New Gun Range, Fort Prospect

Addenda #1

Date: March 6, 2017

Project No. 31-263-76

E101

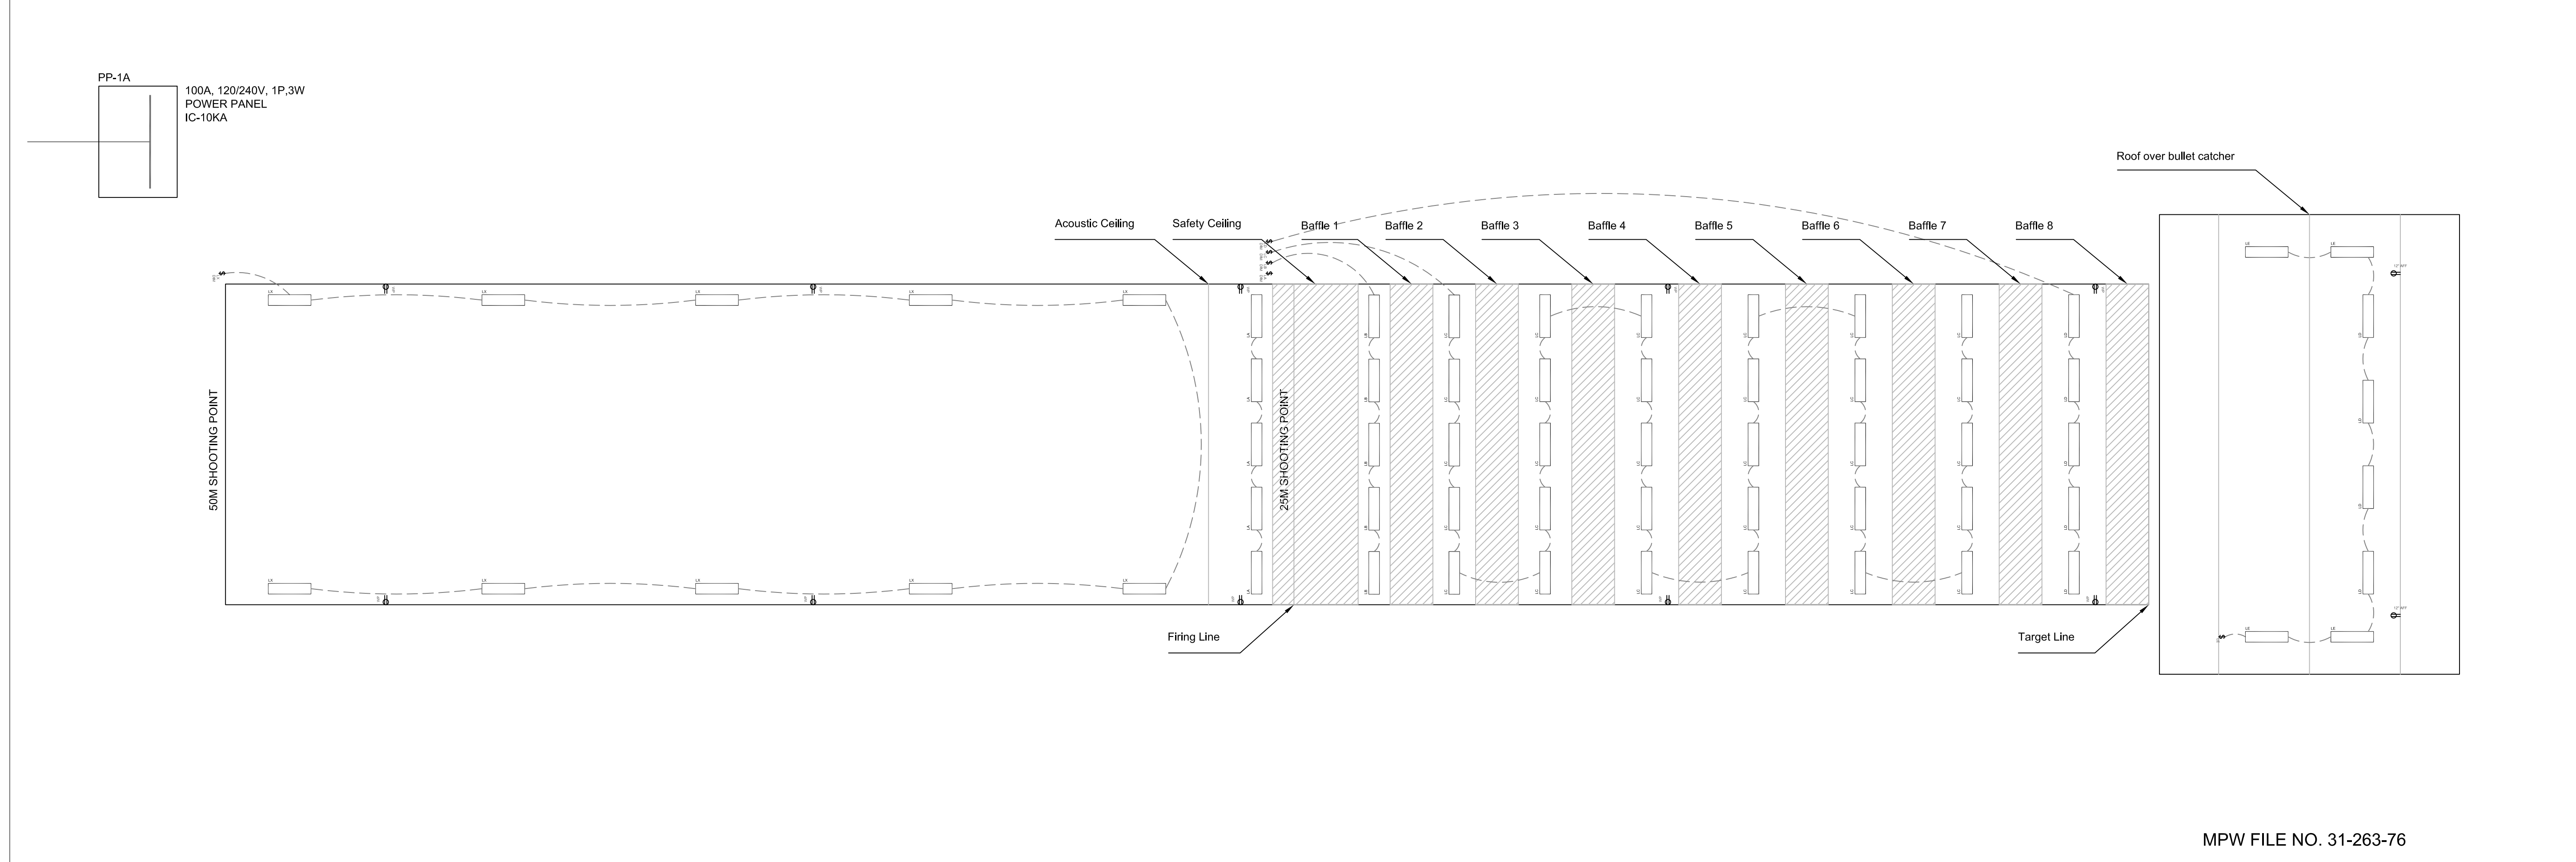
1.1.1.20 Supply and install all electrical materials as shown on Drawing E101 "General Notes, Panel Schedule, Lighting", complete in every respect.

2.1. Add electrical drawing E101 "*General Notes, Panel Schedule, Lighting*".
